REV. 3-21-17

Planning Review

PRIVATE FIRE MAIN 2

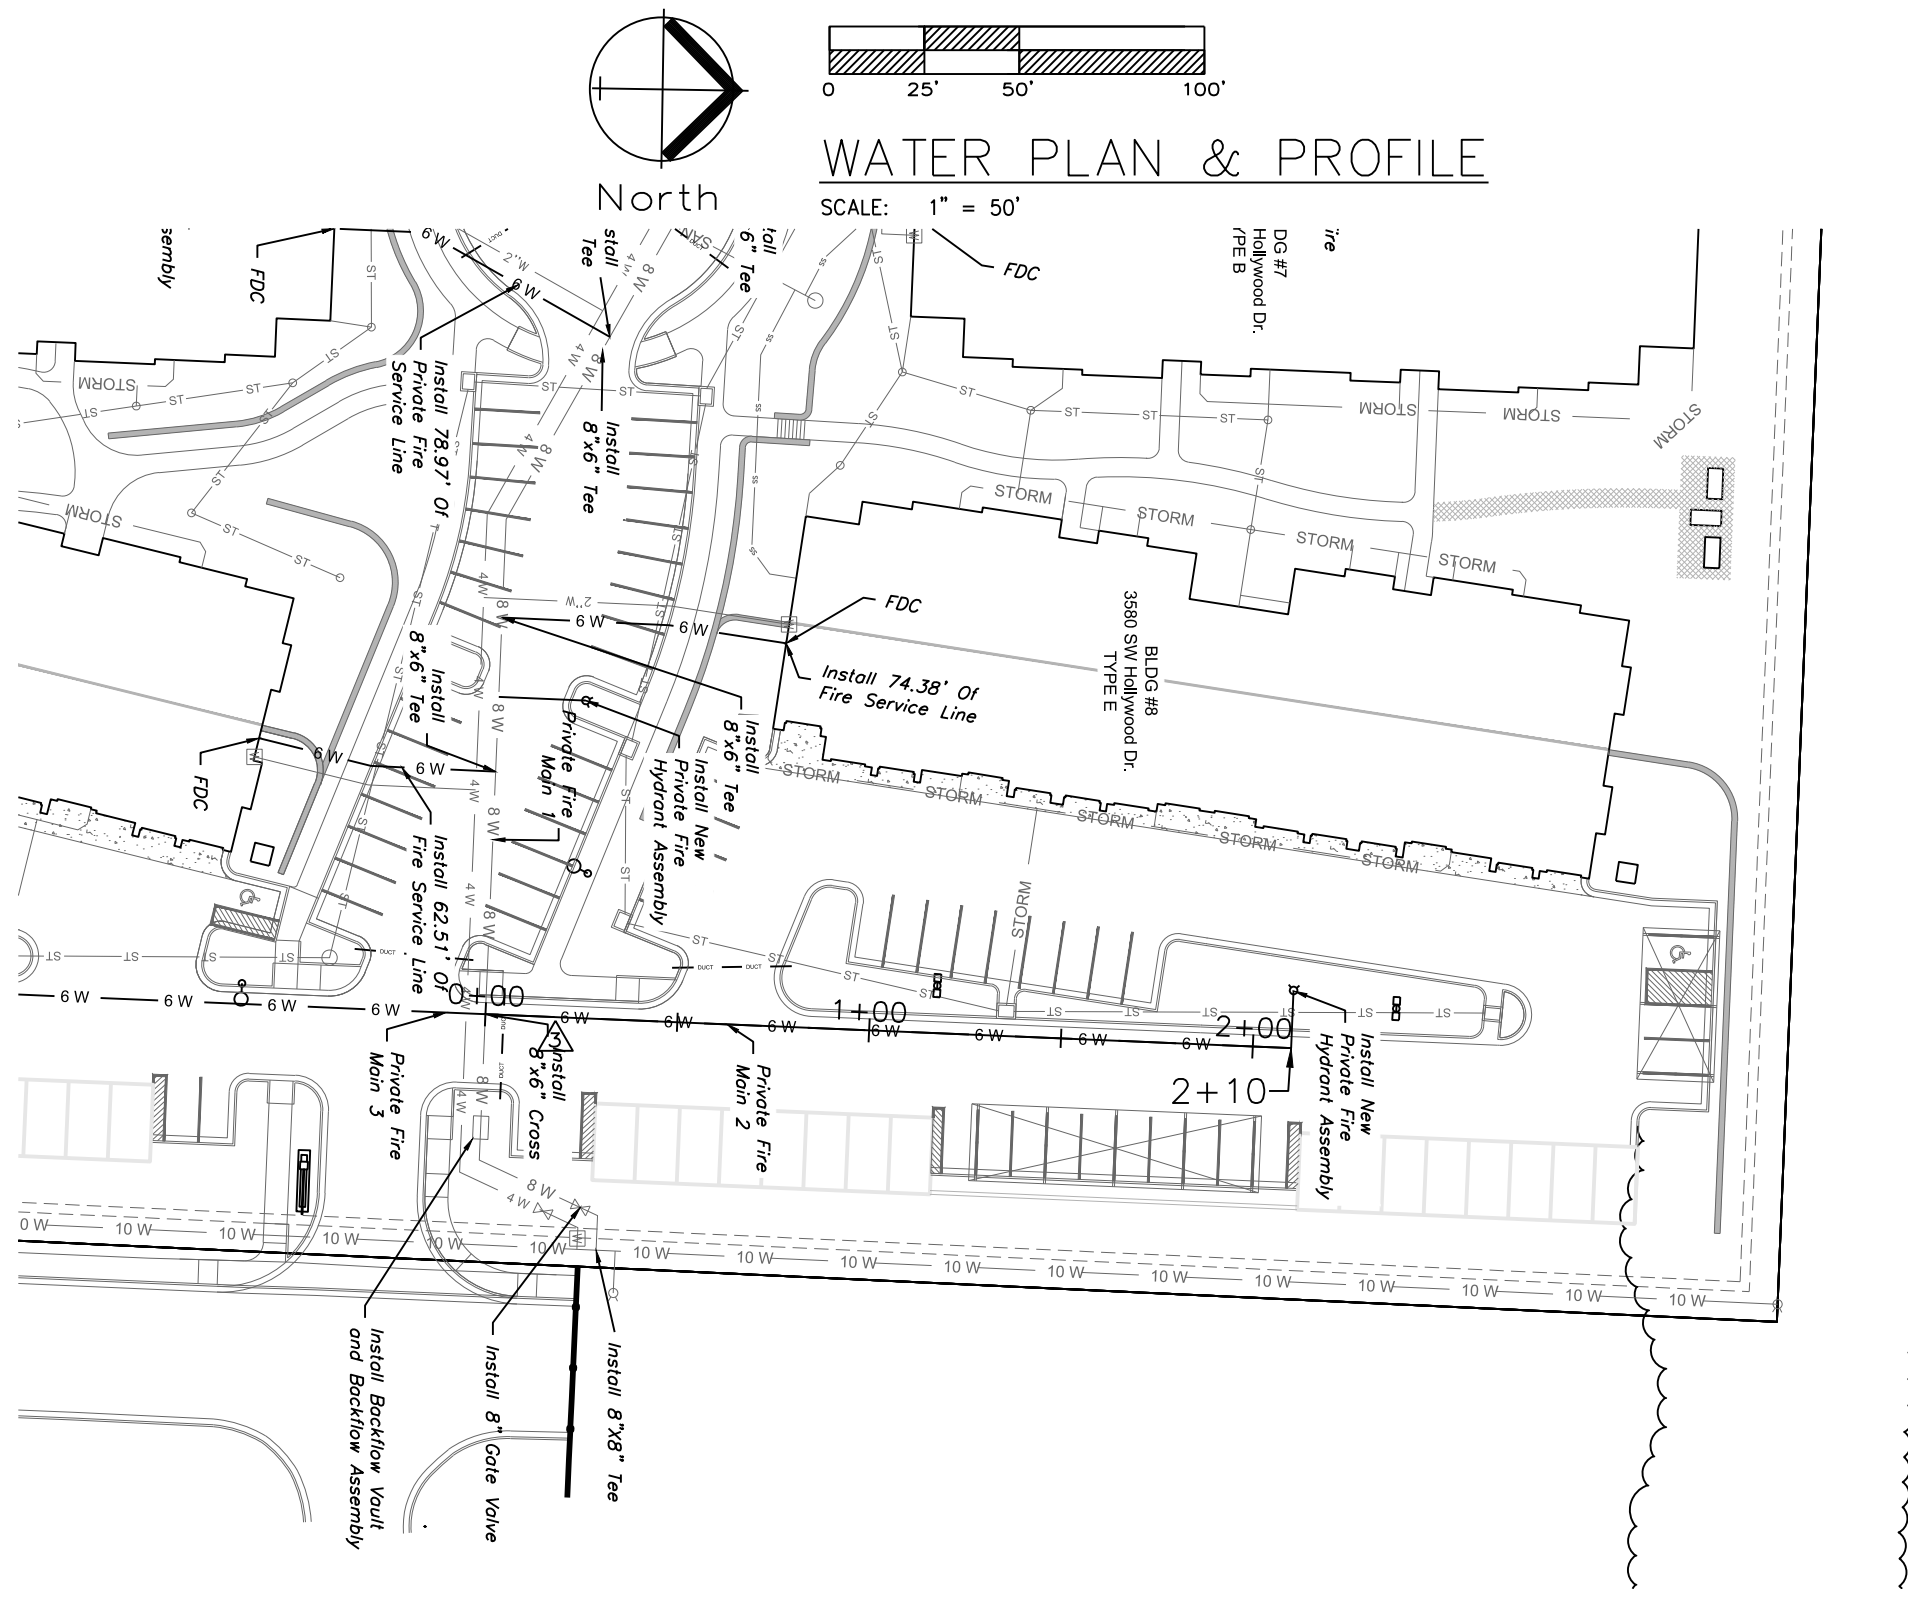
- Relocated the monument signs to be outside the easements.
- Architectural drawings are to match the water on the civil drawings.
- Updated the building addresses as requested.

- Labeled the sanitary and water lines as private as requested.
- Removed the cover sheets for the private water and sanitary.
- Provided locations for the domestic water lines as requested.

- FDC are located on the plans.

- Removed ramp.
- Added Stair.

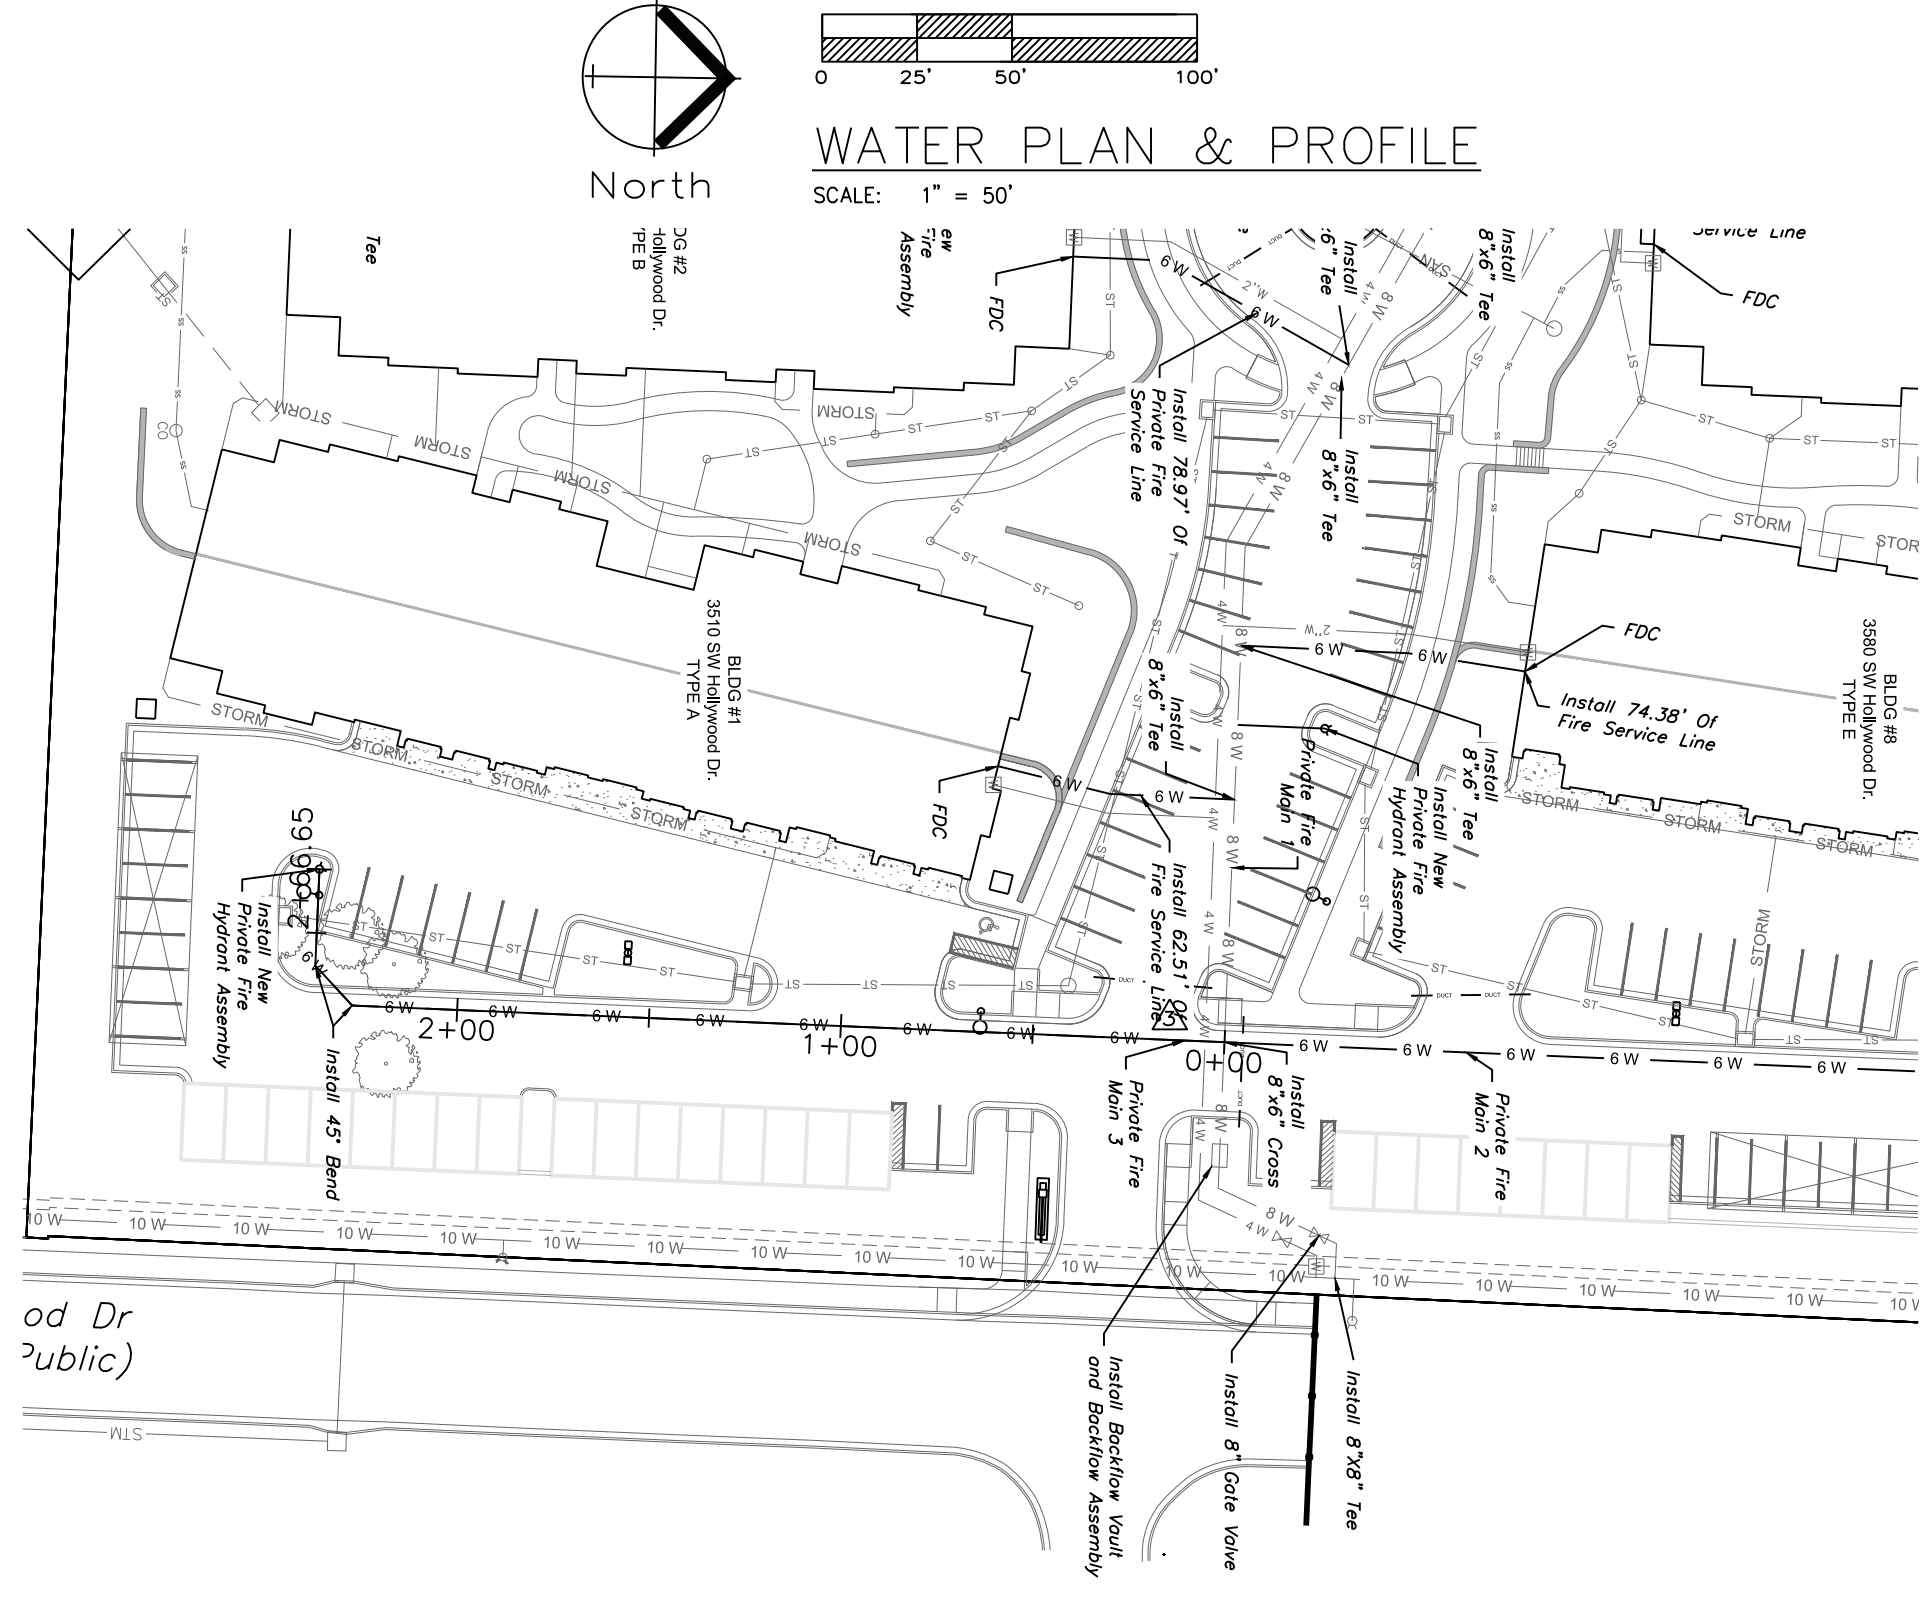
- Reconciled Water Line 1, 2, and 3 locations.

- Water Lines have been altered to provide a separate Fire Line and Public Line.
- 2" Water Meters are being used for this project and are located near the buildings.
- Provided note stating that the public lines along Cheddington Dr. and Hollywood Dr. are part of a separate construction set.
- Changed the note stating the use of 6" fire line shall be DIP shall not be used for this project.
- Removed the note stating to tap the fire line.
- Reconciled the fire lines and the domestic lines to be separated.
- Relabeled the profiles as requested.
- Provided utility crossings in the profile views.
- The color scheme is due to the printer malfunctioning.
